UNITED STATES
NUCLEAR REGULATORY COMMISSION
REGION I
631 PARK AVENUE
KING OF PRUSSIA, PENNSYLVANIA 19406

Subject: Special Inspection No. 50-443/86-52

Report No. 86-52

PHOTO NO. 5, AIR HANDLING UNIT (REF. ALLEGATION NO. 18)

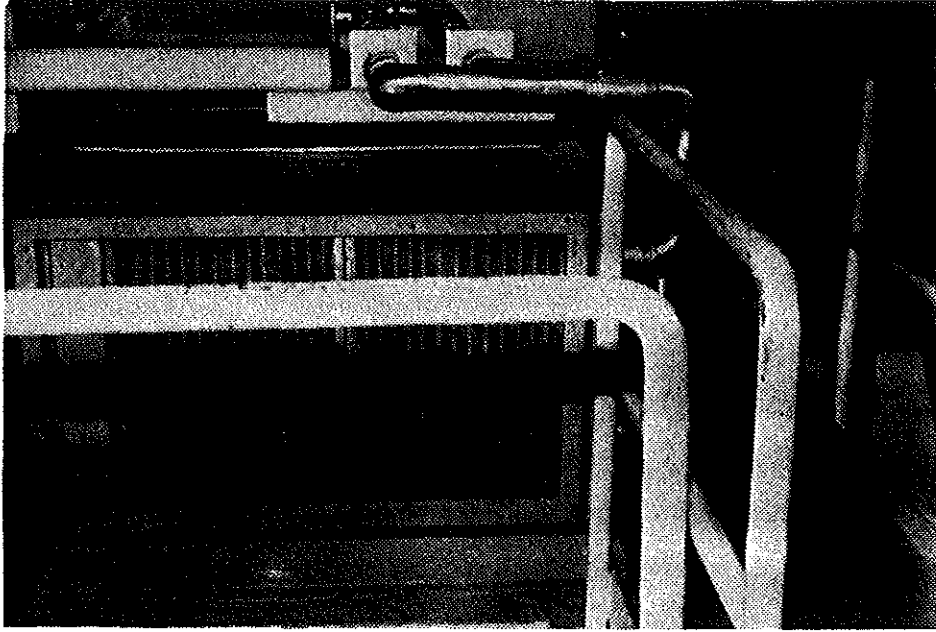
There is no evidence or presence of dirt or debris in the equipment vault area or equipment, the allegation was not substantiated.

PHOTO NO. 7, CONDUITS AND J-BOX AT ELEVATION 7'-0" IN THE PRIMARY AUXILIARY BUILDING (REF. ALLEGATION 19)

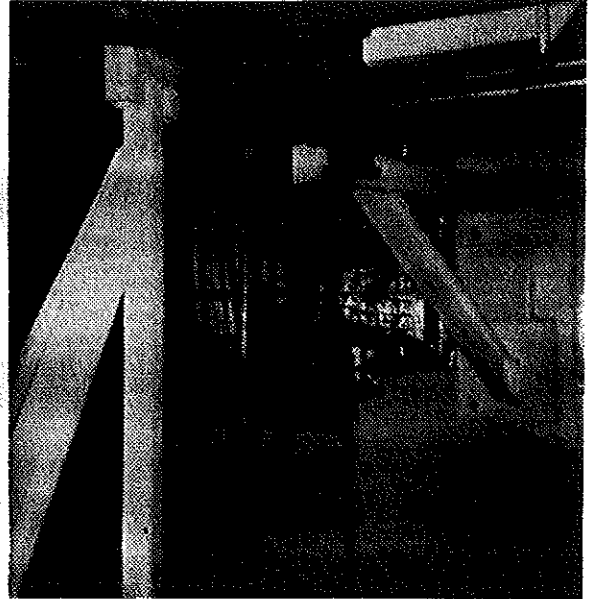
The NRC inspector examined areas of the PAB building (photo no. 7 and photo no. 8) that closely resemble areas described by the allegor in a sketch attached to the November 10, 1986 response to the NRC questions of November 5, 1986 by the Project Coordinator of the Employees Legal Project. The NRC inspector found no evidence of a fire in any of the areas examined.

PHOTO NO. 11, FEEDWATER HEATER BEING CHECKED FOR LEVEL INSTALLATION (REF. ALLEGATION NO. 55)

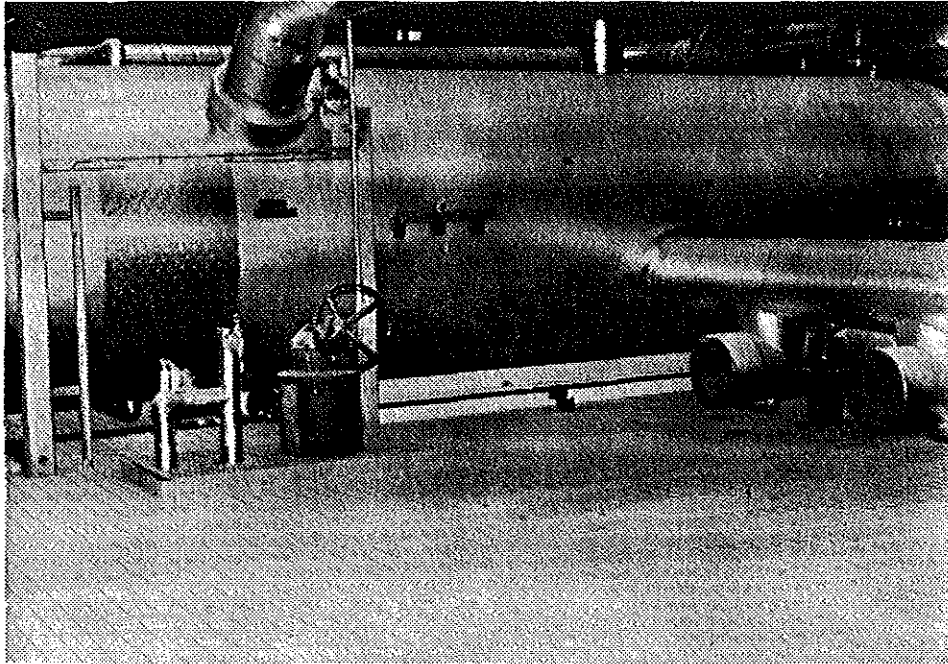
This allegation was not substantiated. During investigation of the allegation, all items inspected by the NRC were found to be installed in accordance with design drawings and equipment manuals. While it is true that the B31.1 as-built program was cancelled, the B31.1 code conformance was met by installation practices and procedures. No safety-related equipment deficiencies could be identified as a result of these allegations.
